E	13.02.25	HG	Red annotations added drawings to denote the changes made to the design as part of the Section 73 submission as requested by MCC.
D	07.01.25	HG	Client feedback recieved at building regulations stage. Package updated accordingly prior to Section 73 submission
C	09.12.24	HG	House type revised as part of NMA submission. Following receipt of levels and building regulations development
B	07.11.24	JW	Design revised to incorporate solar panels as part of NMA submission
A	23.10.24	JW	Design reviewed and subsequent updates made as part of NMA submission for client review
3	15.12.23	JW	GIA and room areas added to the drawings
2	18.07.23	JW	House type ammended following value engineering. File Identifier and title block updated to supersede model P5-BTP-02-XX-M3-A-House Type 4. Information provided regarding bat and swift boxes in line with EIM Ecology reports
1	18.04.23	HG	Bike stores updated in line with client comments following meeting

PROJECT:
Kenyon Lane - P500 Block 1 - Plots 1-4

DESCRIPTION:
Block 1 - Proposed Plans 00

JOB NO: STATUS CODE: DRAWING NO: REV
3785 S2 165 E

Block 1 - Ground Floor Plan
1 : 50

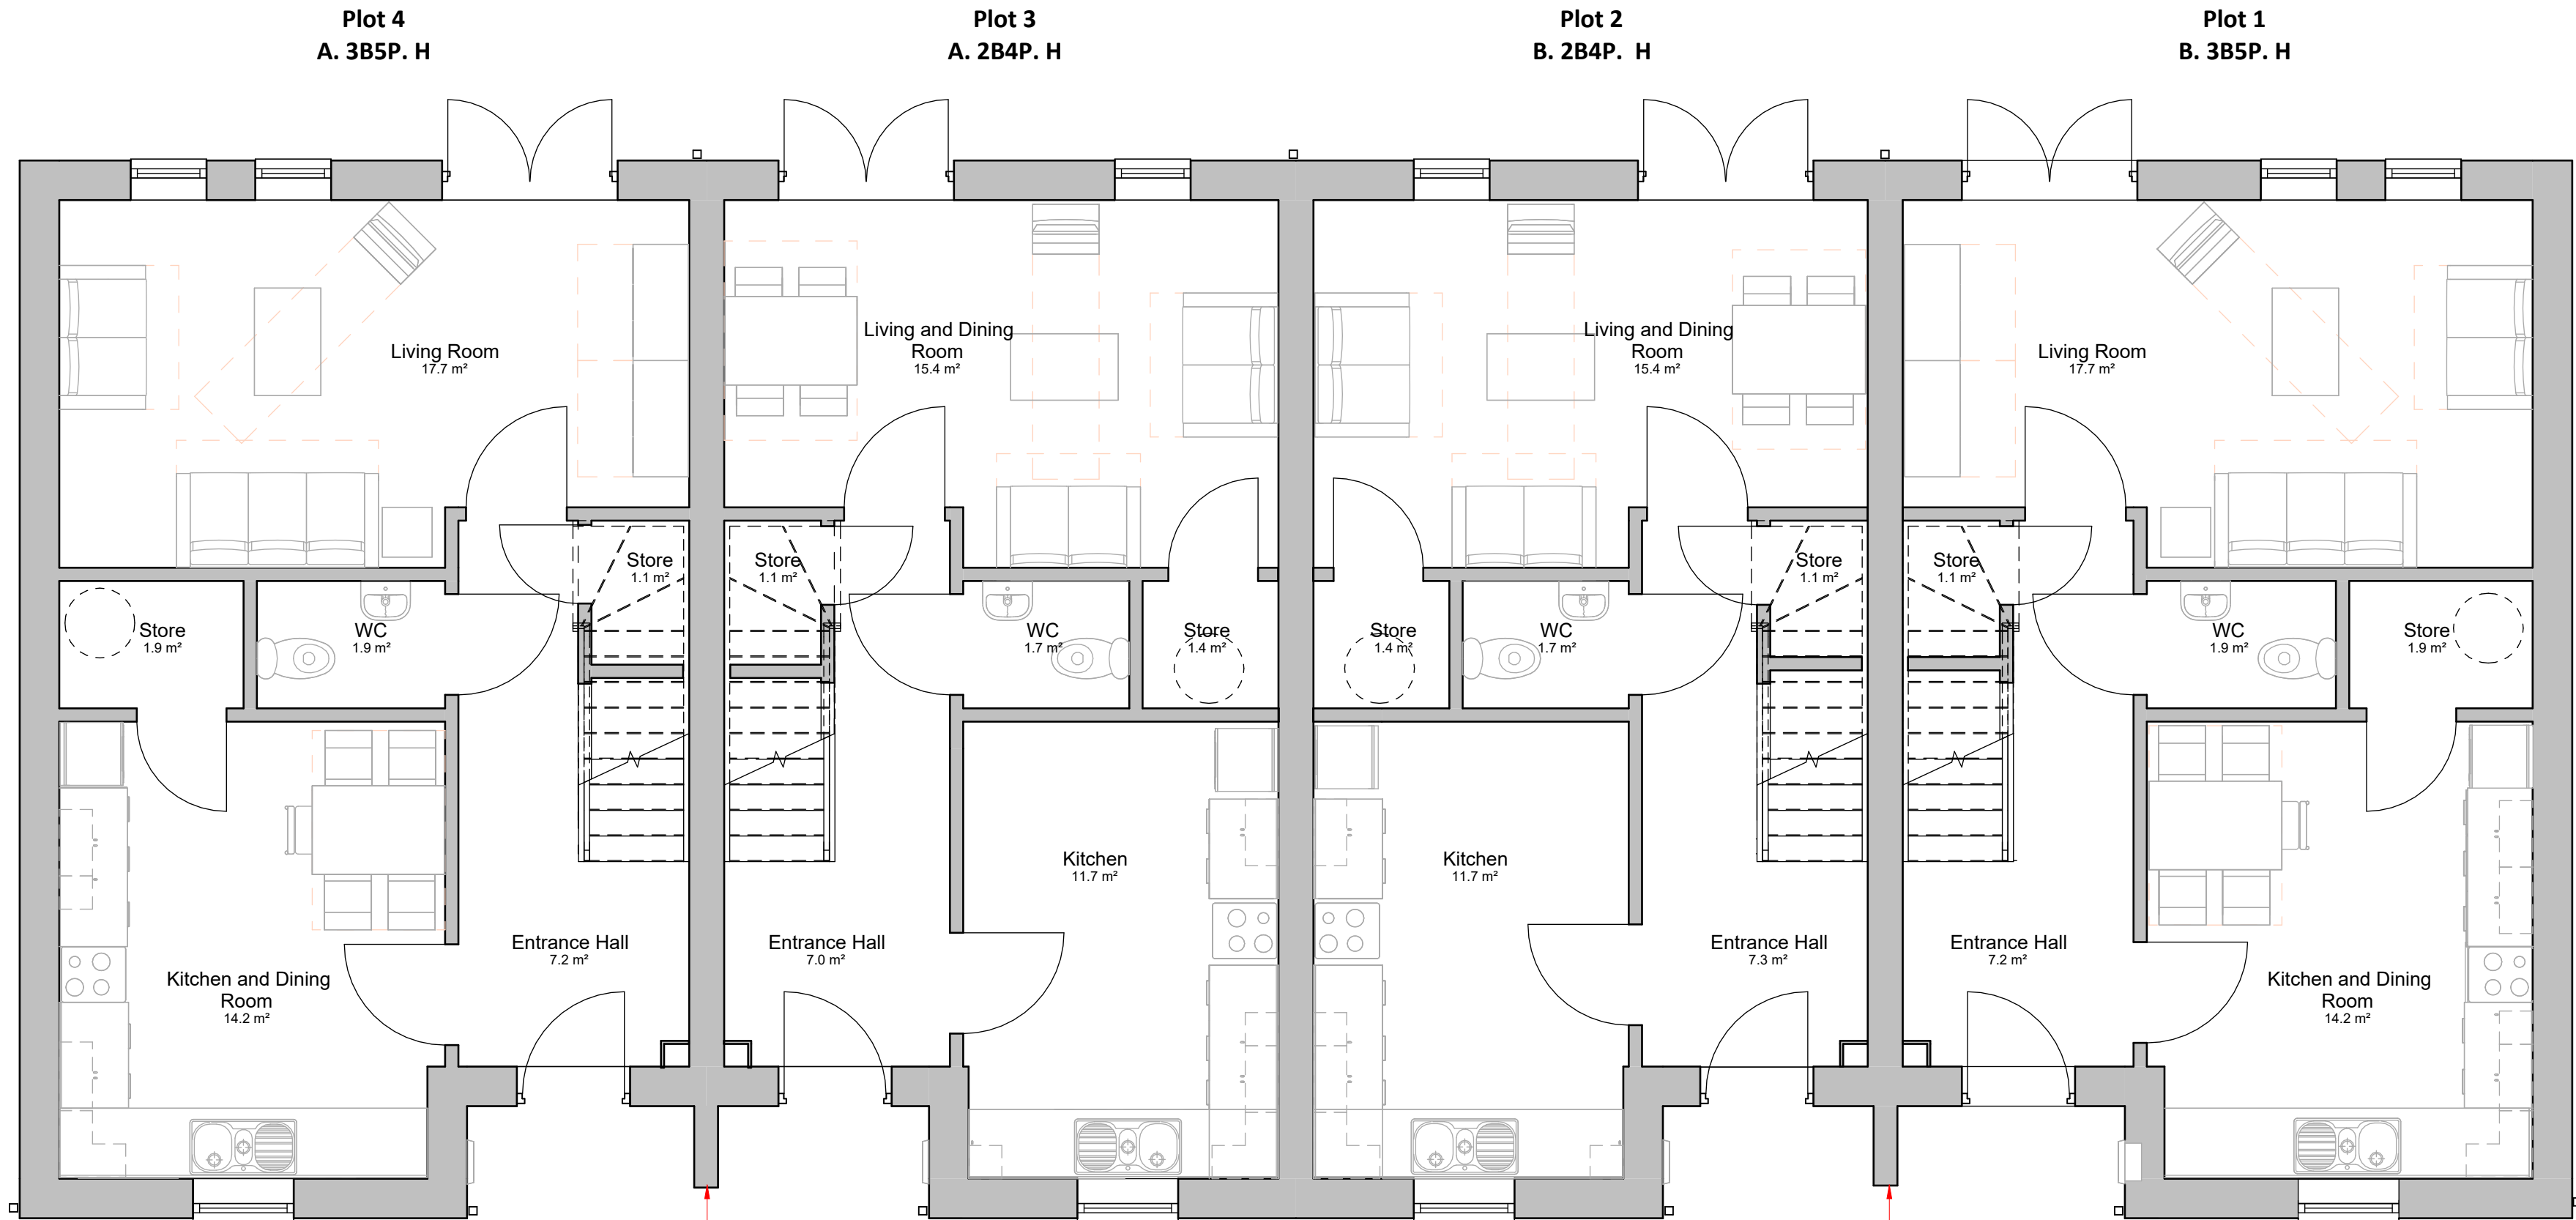
*Internal layouts updated to accommodate cylinder store. 1no. meter box to front of each unit removed in accordance with proposed installation of ASHP and cylinder system
